MEMORANDUM

Re: **Completion Report - Installation and Testing of Well 8-97 and Re-evaluation of Groundwater Supply Potential of Quadra Sand Aquifer at Deep Bay.**

As requested by G. Smail, Land Officer, Land Management Branch, British Columbia Assets and Land Corporation, the November 25, 1997 report entitled *Completion Report - Installation and Testing of Well 8-97 and Re-evaluation of Groundwater Supply Potential of Quadra Sand Aquifer at Deep Bay* prepared by Pacific Hydrology Consultants Ltd. for Deep Bay Waterworks District has been reviewed.

WELL LOCATION MAP

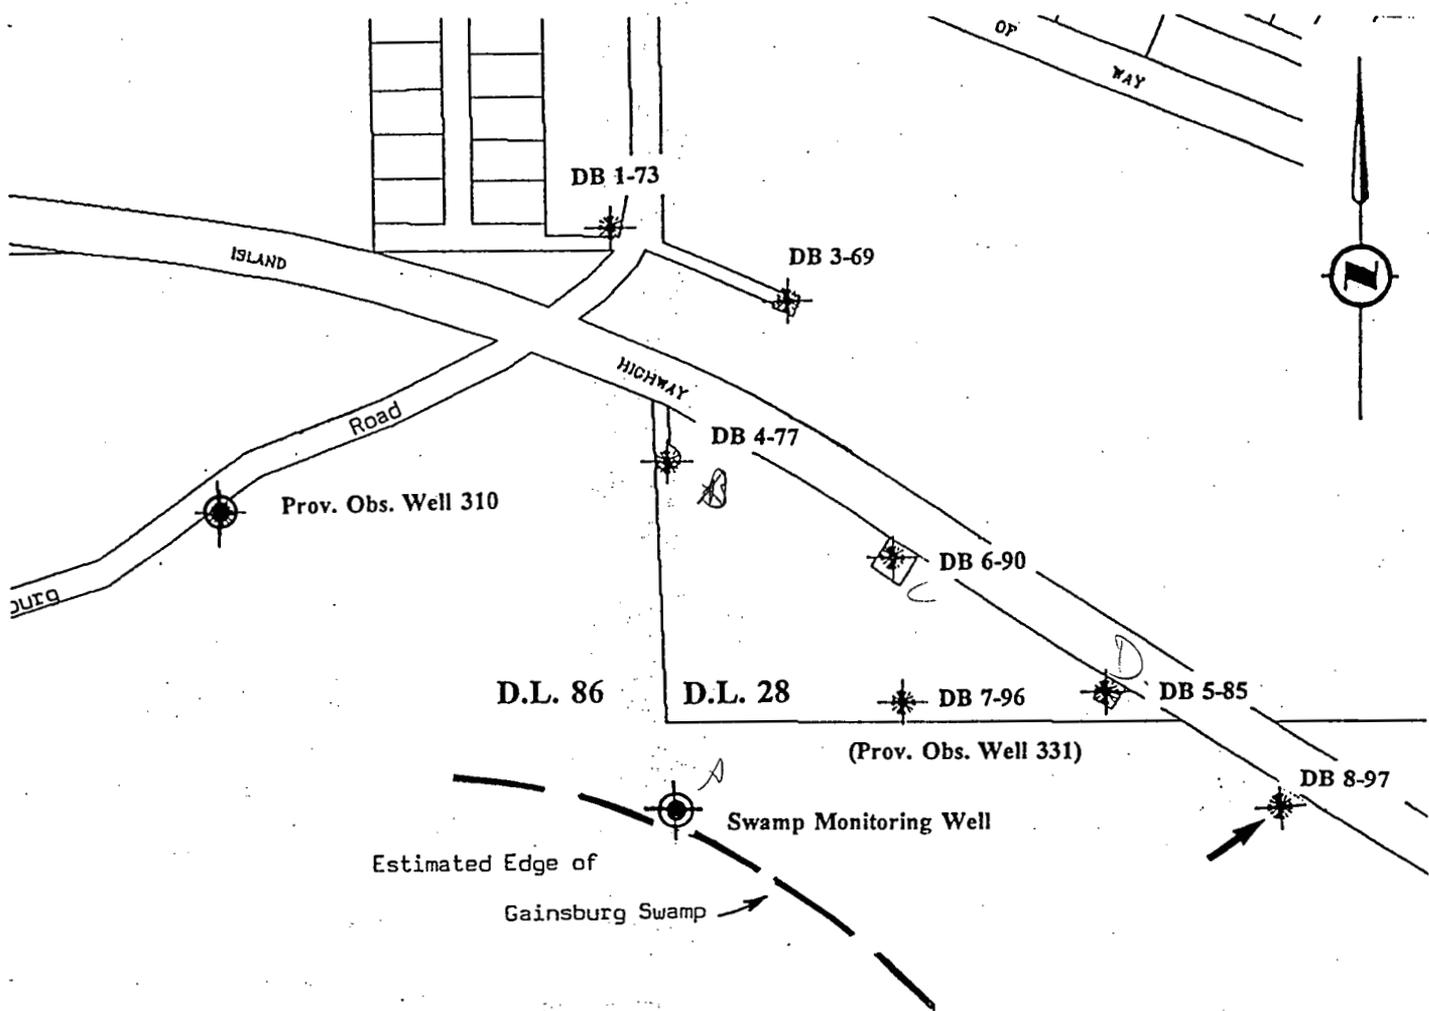
DB 8-97 is located between Bowser and Deep Bay on D.L. 86 and approximately 150m (490 ft) southeast of DB 5-85 and adjacent to the Island Highway (Figures 1 and 2).
